Subject: Arkansas Nuclear One - Units 1 and 2
Docket Nos. 50-313 and 50-368
License Nos. DPR-51 and NPF-6
Follow-up to May 8, 2000 Unit 1 Low Pressure Injection /Decay Heat Removal
Pump Pre-decisional Enforcement Conference

**Attachment 1
Requested Information**

Fault/Decision Tree

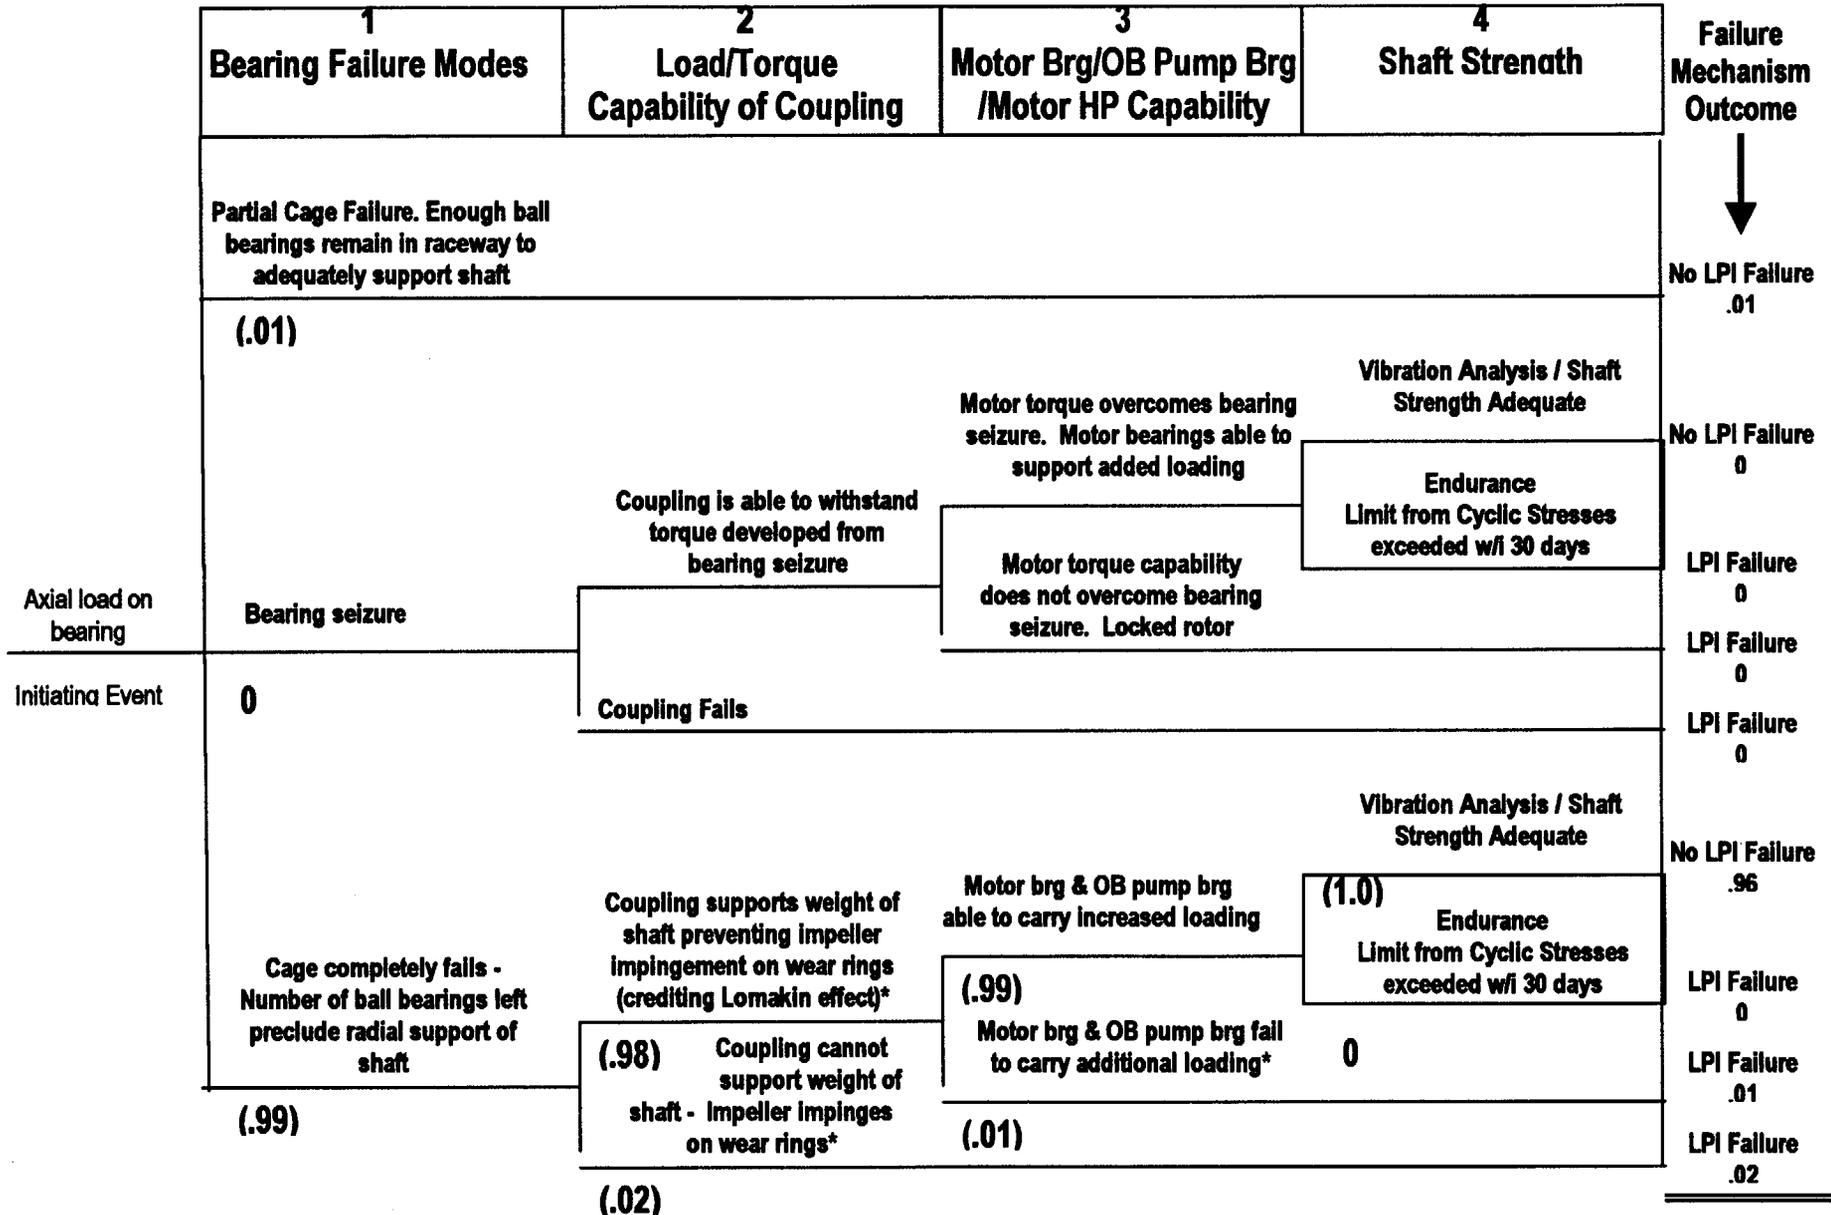
4. Discuss the fault/decision tree areas of conservatism in regard to the coupling failure mechanism and the bearing failure mechanism, include other analytical margins in the analysis.

During the conference two areas of conservatism were discussed in the fault/decision tree portion of the presentation. Since some of the analyses were not complete at the time the expert panel developed the fault/decision tree, additional conservatism was added in the categories of coupling capability and motor bearing and outboard pump bearing load capability. These failure mechanisms were assigned relative failure values of .02 and .01. As discussed in item 3, the completed analysis now substantiates both values as conservative since both components have been analyzed as capable of carrying the calculated loads without crediting the Lomakin effect. Therefore, as discussed during the conference, the failure probability of 0.03 assigned by the expert panel is considered conservative and a value closer to nominal would be appropriate. A footnote was added to the fault/decision tree for clarification, this modified version is provided in Attachment 2.

*The fault tree represents the results of the expert panel prior to completion of some of the analysis. Therefore, additional conservatism was given in the categories of coupling capability and motor bearing and outboard pump bearing load capability. These failure mechanisms were assigned relative failure values of 0.02 and 0.01. The completed analysis now substantiates both values as conservative since both components have been analyzed as capable of carrying the calculated loads without crediting the Lomakin effect.
